File: Power.sch

WorldStage, Inc		
Sheet: /Power/		
File: Power.sch		
Title: Power		
Size: B	Date: 24 oct 2013	Rev: 2
KiCad E.D.A. eeschema 4.0.4-stable		Id: 10/15

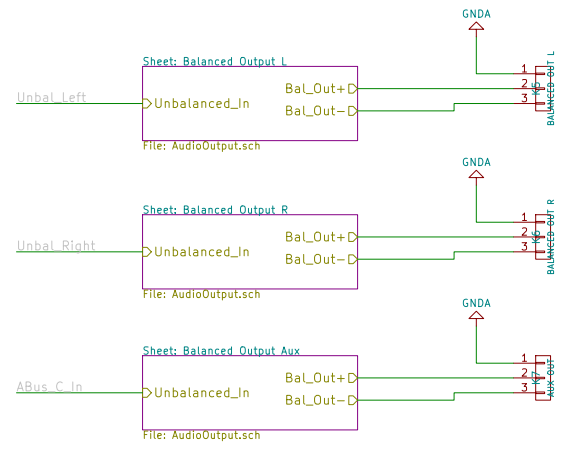
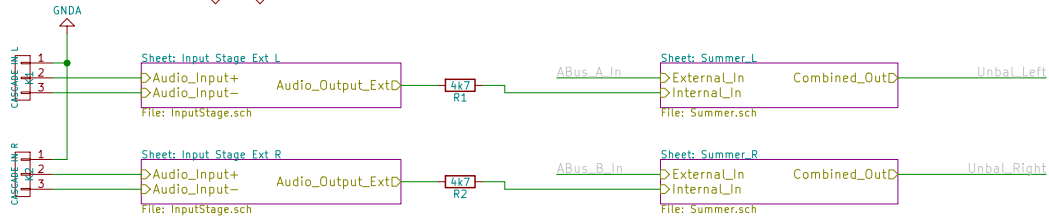
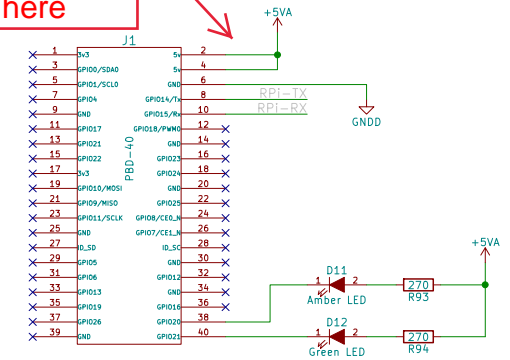
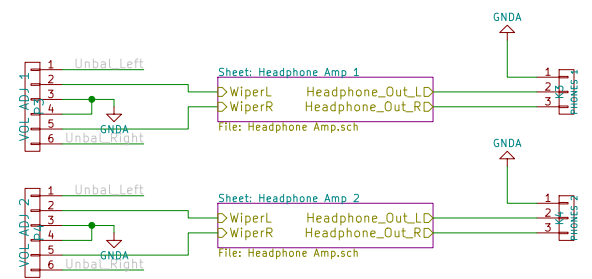
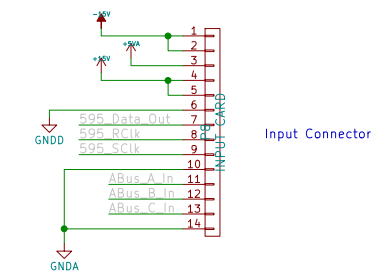
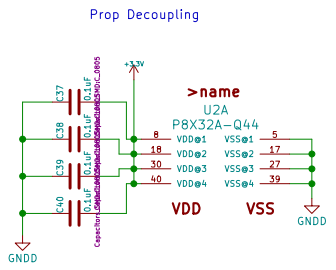
Added 100uF 63V caps between GND and all three power rails. Reduced the frequency of the audible noise, but still very noticable through the headphones.
